# Delaware River Basin Flood Analysis Model Independent External Peer Review Report

Prepared for:  
Federal Emergency Management Agency, Region III  
Delaware River Basin Commission

January 6, 2012

Figure 20. RioFlashboards state variable.

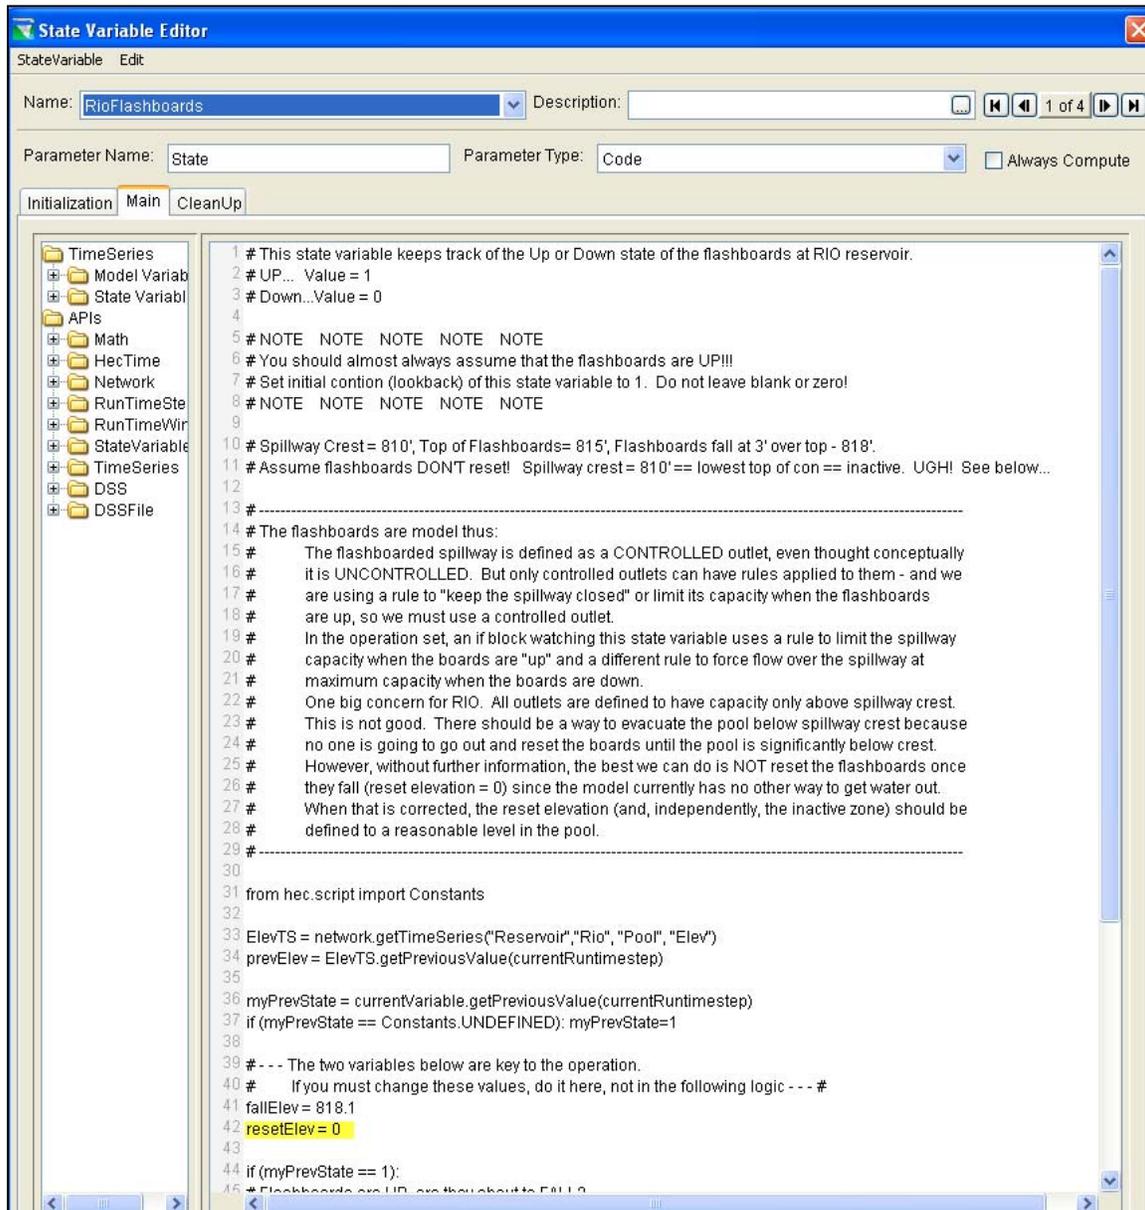
35. Comment - Model. Rio. Similar to the flashboards at Swinging Bridge, the flashboards at Rio failed during the 2005 event and were removed after this event. As shown in Figure 20, setting *resetElev* = 0 ft and a state of “DOWN” position at the start of the simulation for the 2006 event would keep the flashboards down for the 2006 event. Again, we suggest describing this modeling approach in the report so that the users will be more aware of a need to change this elevation for future flood simulations if the flashboards have been rebuilt.

Comment Response - Agreed. The observed conditions were described in the report, but the alterations to the script were not. The following paragraph was added/modified in section 4.3.2.7 of the report to complete the explanation:
